SB-937

SERVICE BULLETIN AMATEUR RADIO

SUBJECT	DATE
TM-721A AF PA WHITE NOISE WITH SQUELCH ON	6/02/88

FIGURE 1

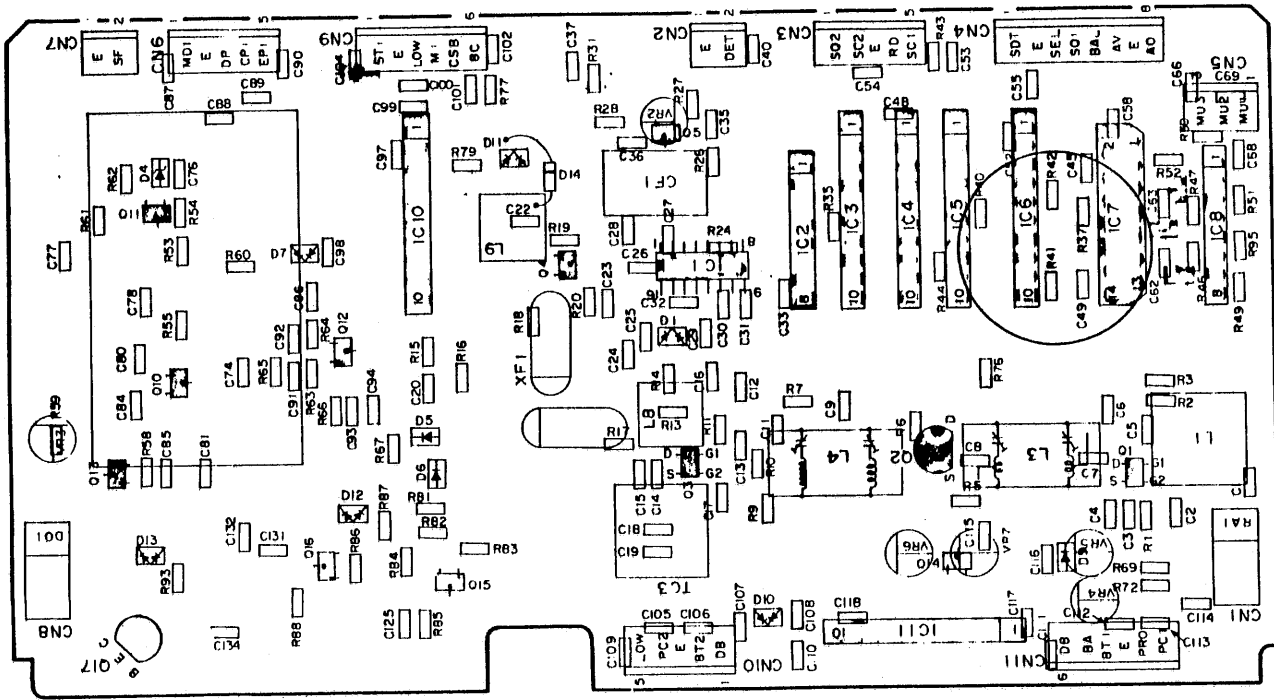
9. On the component side of the Control board (the side with the majority of connectors) replace R7 with an 18K ohm chip resistor (Figure 1).
10. Assemble the front panel by reversing steps 5 - 8. Do not forget to run the two short coax cables (mentioned in step 8) under the Control unit.
11. On the foil side of the TX-RX (UHF) unit, remove chip resistors R37 and R41 (Figure 2).
12. On the foil side of the TX-RX (VHF) unit, replace R43 with a 12K ohm chip resistor (Figure 3).
13. Assemble the transceiver by reversing steps 1 - 4.
